Subject: Kairos Power LLC
Topical Report Submittal
Scaling Methodology for the Kairos Power Testing Program

SUBJECT: SAFETY EVALUATION FOR KAIROS POWER LLC TOPICAL REPORT "SCALING
METHODOLOGY FOR THE KAIROS POWER TESTING PROGRAM"
(REVISION 1) (EPID NO. L-2019-TOP-0011 AND CAC NO. 000431)

TOPICAL REPORT KP-TR-006, REVISION 1,

“SCALING METHODOLOGY FOR THE KAIROS POWER TESTING PROGRAM,”

Figure 12. Prandtl Number Matching and Distortions for Flibe at Temperatures Between 550°C and 750°C ¹, and Heat Transfer Oil at Temperatures Between 58°C and 118°C ².

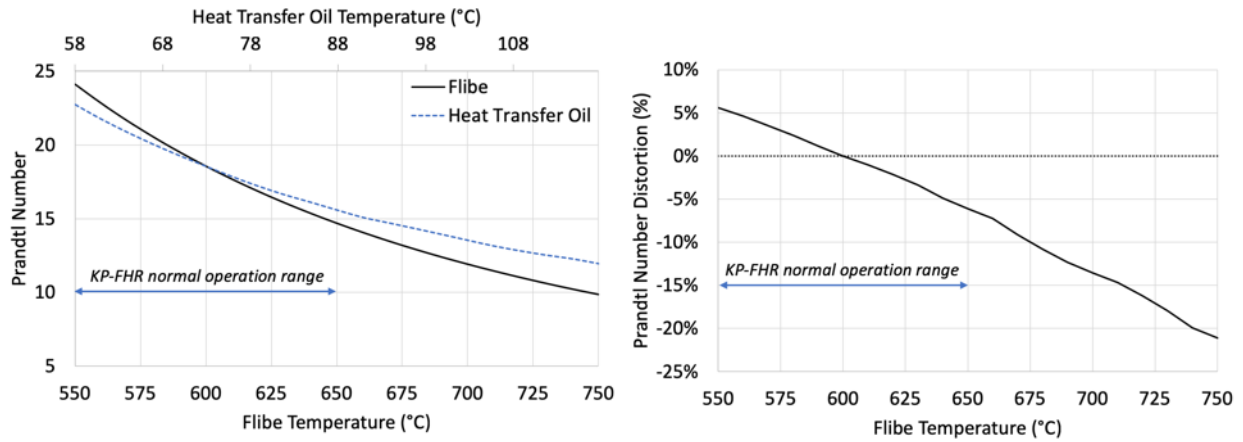
Section 5 of the TR describes the use of surrogate fluids in scaled experimental activities for the KP-FHR. Additionally, the use of surrogate fluids is assumed throughout the TR. Section 5 of the TR clarifies that the motivation for the use of surrogate fluids is to allow for the investigation of relevant fluid and heat transfer phenomena at significantly smaller scale, reduced temperatures, fewer required resources, and to enable the use of available and accurate instrumentation. The NRC staff also recognizes the added safety benefit of eliminating a Beryllium containing coolant from the associated tests. Section 5 of the TR also references Table 12 and Figure 12, which provide illustrations for how a heat transfer oil can be used in place of prototypical Flibe in scaled experiments. The NRC staff performed calculations, using the thermophysical properties of the heat transfer from Table 13 of the TR and the thermophysical properties for Flibe from the Kairos Power reactor coolant TR (Reference 12), and was able to obtain the results presented in Table 12 and Figure 12 of the TR.
